5	Name plate	1	Al			
4	Aluminum plate	1	Al			
3	Screw	1	Brass alloy	M4*P0.7*5L		
2	Metal insert	1	Zinc Alloy △	$\phi 9.2*8L*\phi 6.4$		
1	Housing	1	ABS			
No	Description	Q'ty	Material	Specification	Finish	Remark
Drawn	Checked	Approved	Model Name		CONTROL KNOBS	
黃洋	周才輝	<i>Sma</i>	Customer No.	450-2037-GRX	Model No.	RN-113A
11/24/14	11/24-14	11/24-14	Unit	mm		Rev. 3

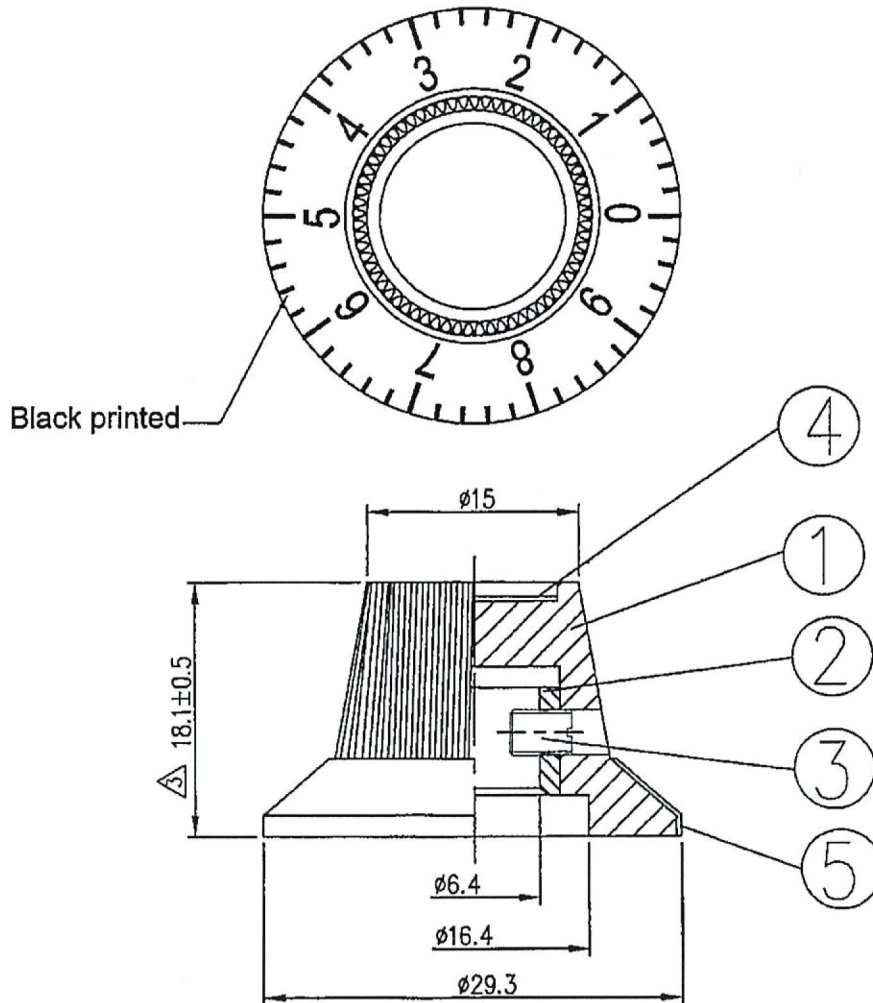
Date	Name	Description	No.
08/26/06	徐洲迎	修正飾環方向	△
11/16/07	曹盈芳	Change Insert copper housing Copper alloy -> Zinc Alloy	△
11/24/14	黃洋	依實物修改尺寸公差18.1改為18.1±0.5	△
